CITY OF ALBUQUERQUE

Planning Department

RE: **Lot 8 Block 11, Volcano Cliffs, Unit 18, SAD 228
6520 Petirrojo NW
Grading and Drainage Plan
Engineers Stamp Date 8/11/19 (D10D003H26)**

ENGINEER'S SEAL	LOT 8 BLK 11, U 18 VOLCANO CLIFFS 6520 PETIRROJO ROAD NW	DRAWN BY DEM
DAVID SOULE NEW MEXICO 14522 REGISTERED PROFESSIONAL ENGINEER	GRADING AND DRAINAGE PLAN	DATE 8-12-19
	Rio Grande Engineering 1608 CENTRAL AVENUE SE SUITE 201 ALBUQUERQUE, NM 87106 (505) 972-0899	LOT 8 BLOCK 11 VOLCANO CLIFFS.DWG
8/11/19		SHEET # C1
DAVID SOULE P.E. #14522		JOB #

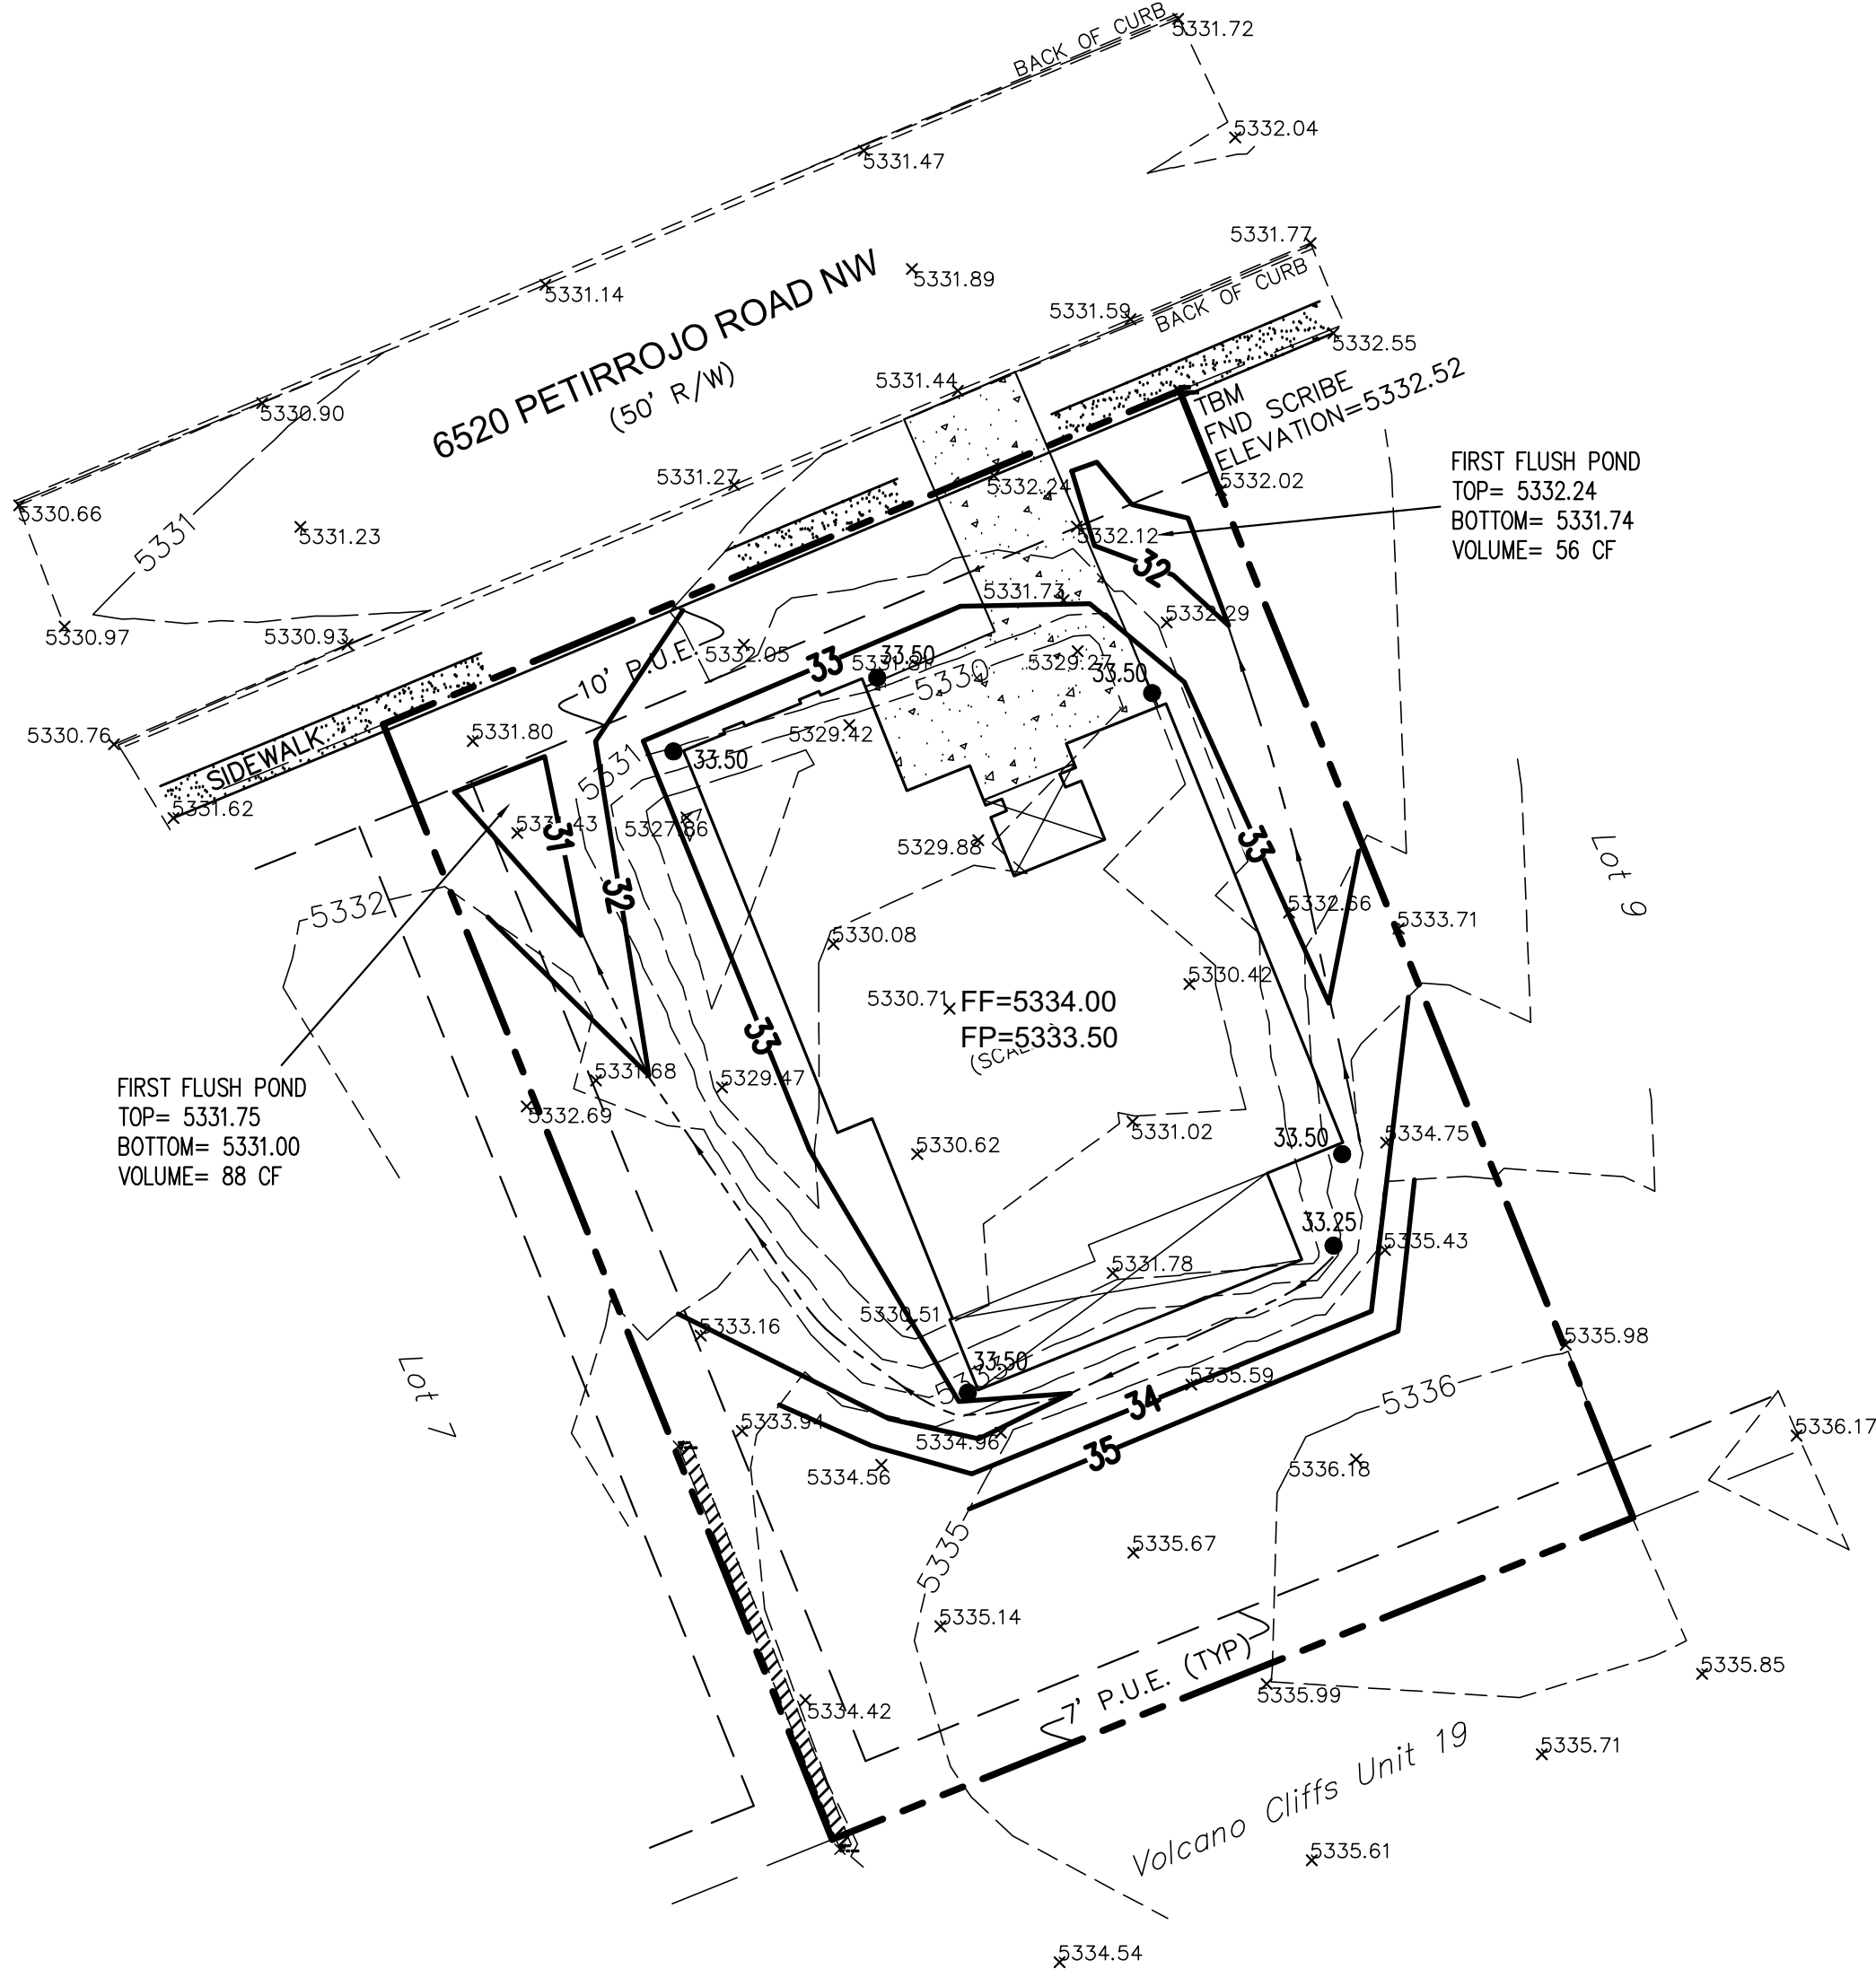
Based upon the information provided in your submittal received 8/12/19, this plan is approved for Grading Permit.

Prior to Building permit approval a Pad Certification will be required, provided by the Engineer or a registered Land Surveyor.

Reiterate to the Owner/Contractor that a separate permit for a garden/retaining wall must be obtained with the approved G&D plan and Pad Certification.

Prior to Certificate of Occupancy release, Engineer Certification per the DPM checklist is required.
